Power Back Door Squeak Noise

Service Category Vehicle Exterior

Section Door/Hatch

YEAR(S)	MODEL(S)	ADDITIONAL INFORMATION
2016 - 2018	RAV4 HV	WMI(s): 2T3, JTM
2013 - 2018	RAV4	WMI(s): 2T3, JTM

Figure 2.

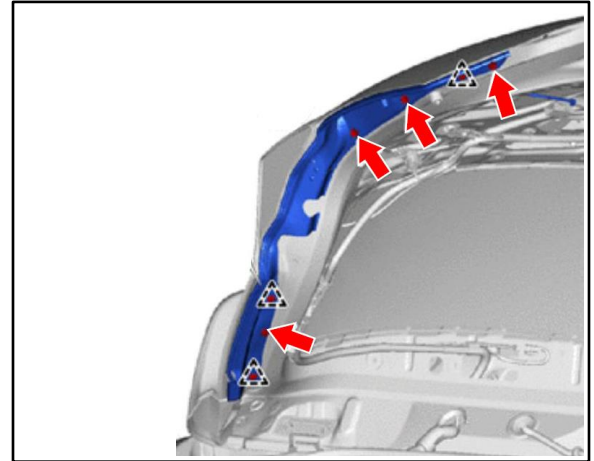
3. Replace the left-hand and right-hand power back door actuators with NEW parts.

- Both power back door actuators MUST be replaced at the same time.
- While removing the screws (four left-hand and four right-hand) on the power back door touch sensors (as shown), confirm hex head size.
- If the existing screws have 10 mm hex heads, they MUST be replaced with NEW 8 mm hex head screws with washer tapping.
